Project No. 07516-42-02  
May 10, 2023

Subject: RESPONSE TO CITY OF SAN DIEGO REVIEW COMMENTS  
NAKANO  
SAN DIEGO, CALIFORNIA

- References:
1. Project Issues Report, Nakano Discretionary Project, PRJ-1076302, City of San Diego, Geology Review Comments prepared by Kreg Mills, dated April 21, 2023.
  2. *Update Geotechnical Investigation, Nakano Property, Chula Vista, California* prepared by Geocon Incorporated dated September 18, 2020 (Project No. 07516-42-02).
  3. *Addendum Geotechnical Report and Response to City of San Diego Review Comments, Nakano, San Diego, California*, prepared by Geocon Incorporated, dated February 9, 2022 (07516-42-02).
  4. *Nakano, Grading and Storm Drain*, prepared by Civil Sense, Inc., dated May 12, 2022.

**GEOLOGIC MAP**  
 NAKANO  
 CHULA VISTA, CALIFORNIA

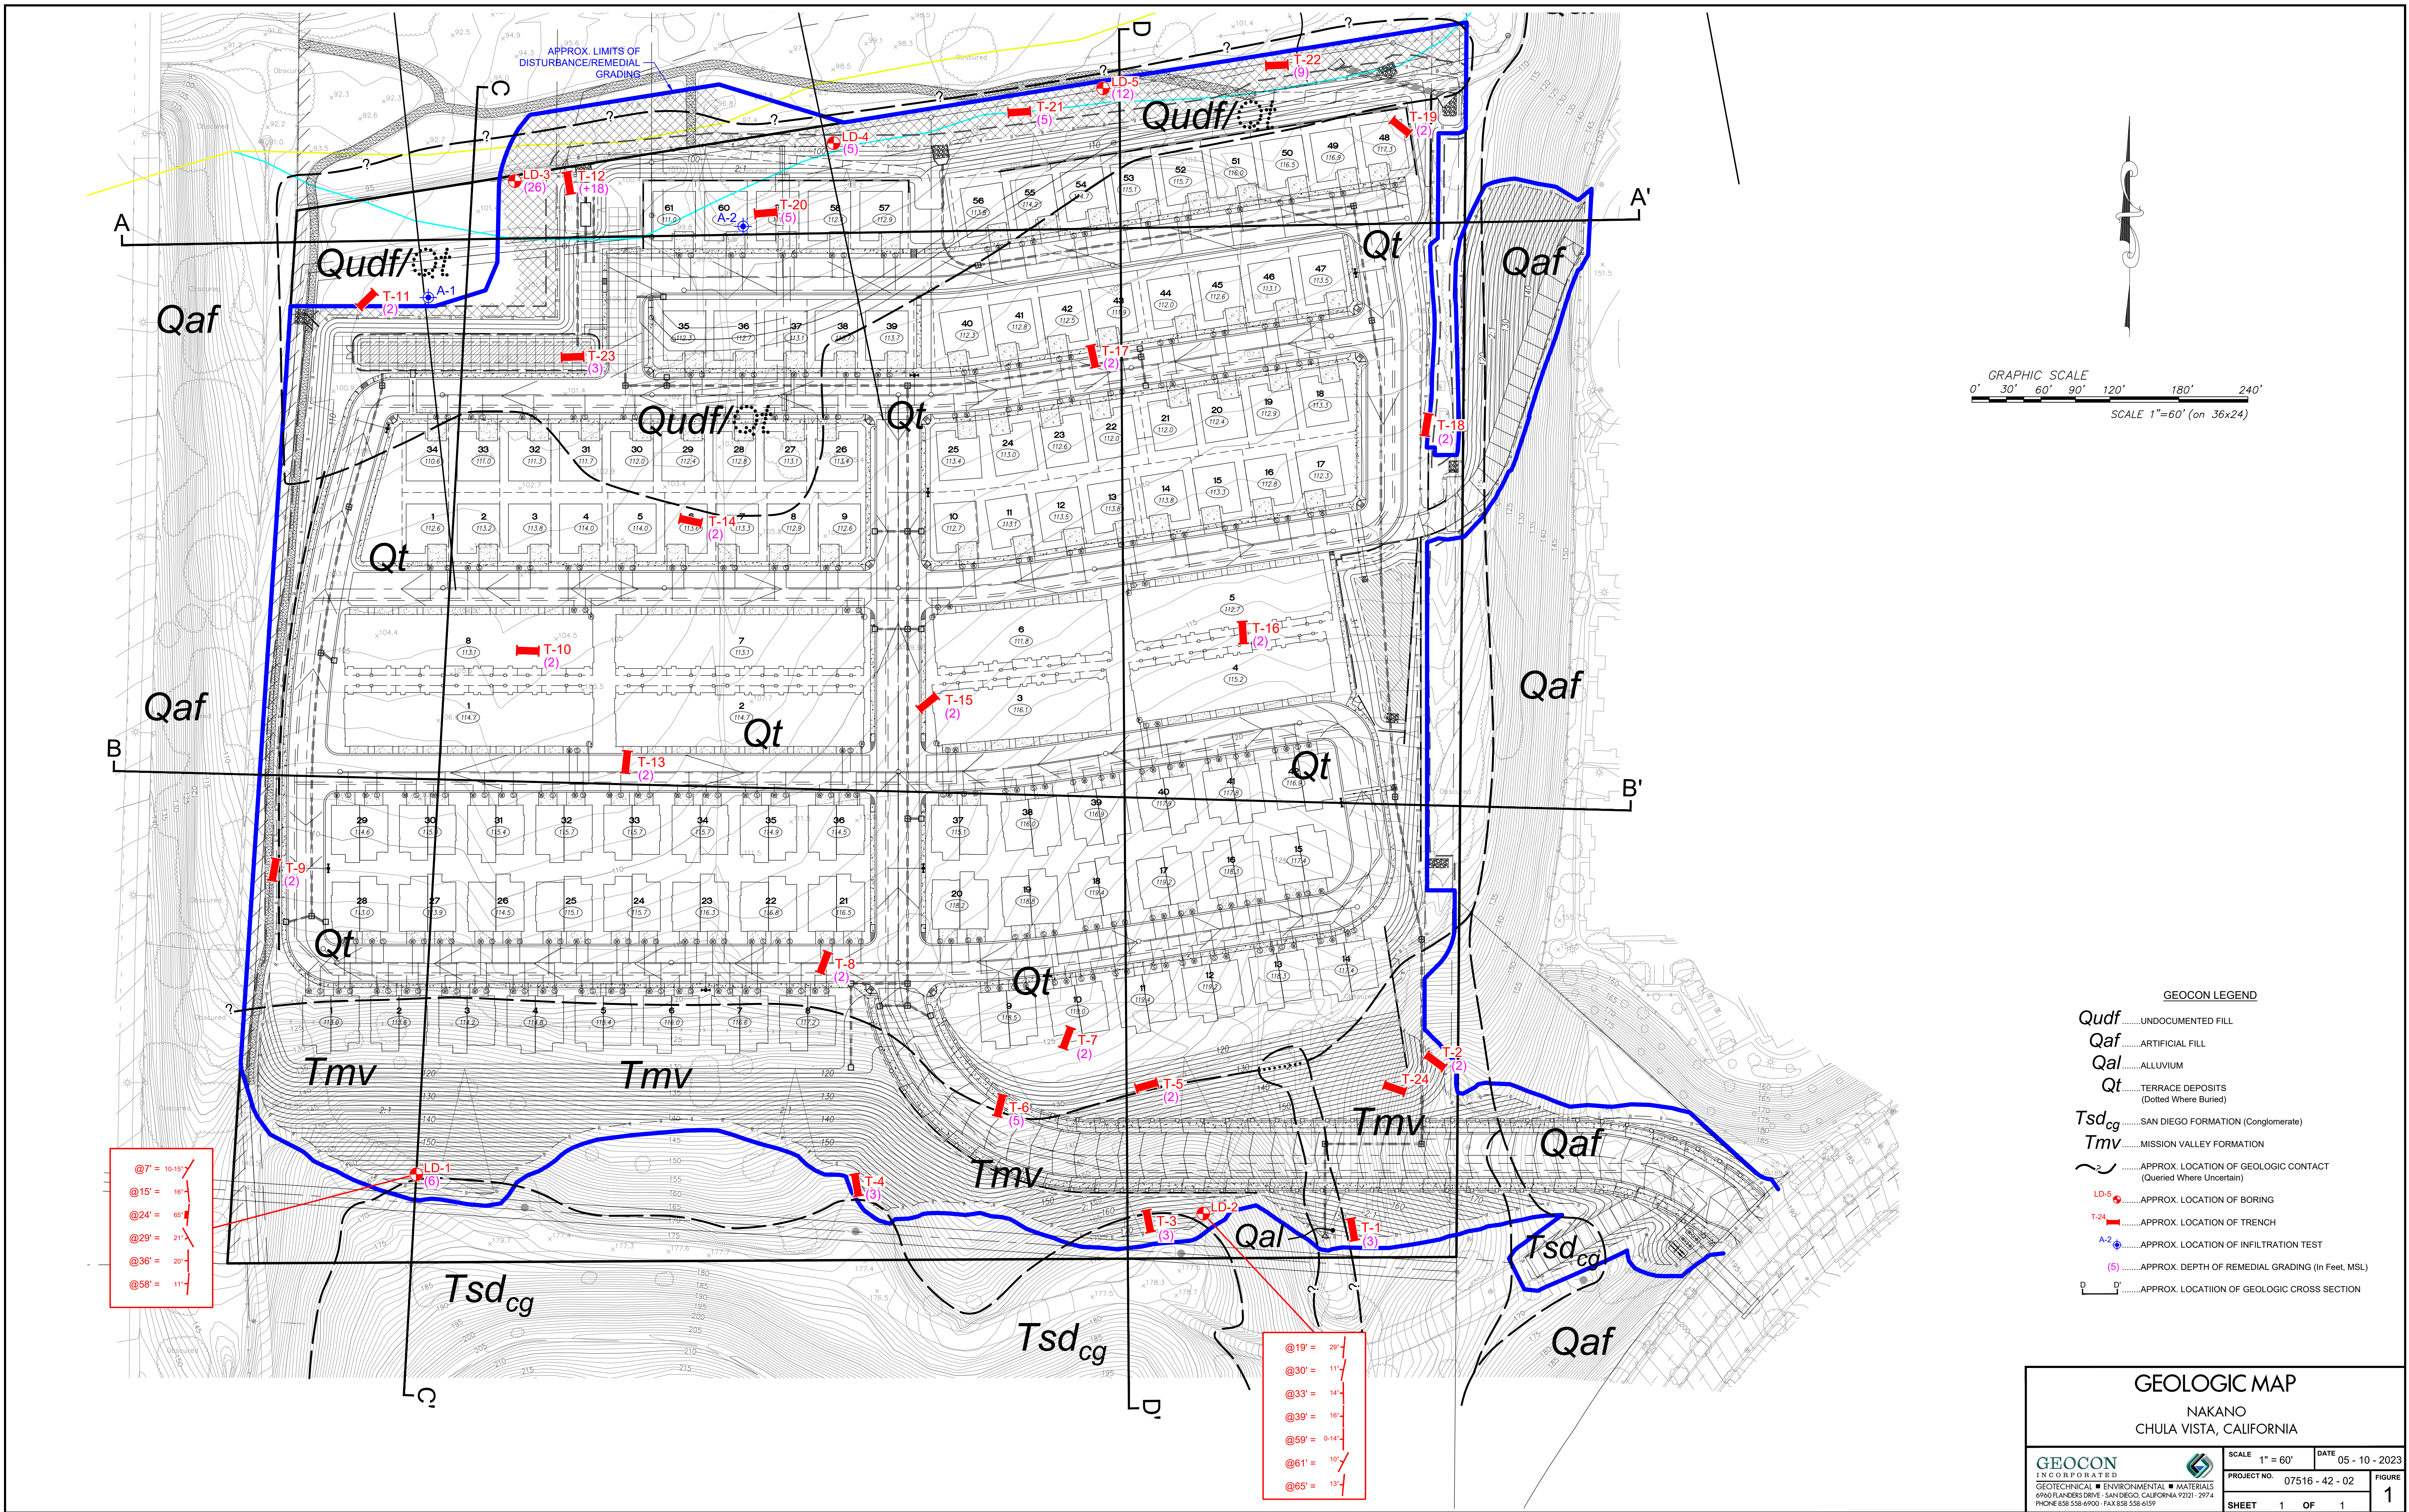
**Issue 51:** *The limits of the proposed development appear to have changed since the submitted report was prepared. Provide an updated Geologic Map (Figure 2) that shows the current proposed development. Circumscribe the limits of anticipated remedial grading on the updated map to delineate the proposed footprint of the project.*

**Response:** Figure 1 is the requested updated geologic map using a CAD file of Reference 4 as the base map. Figure 1 shows the proposed development and the disturbance limits and limits of anticipated remedial grading. Cross sections are provided on Figures 2 and 3.
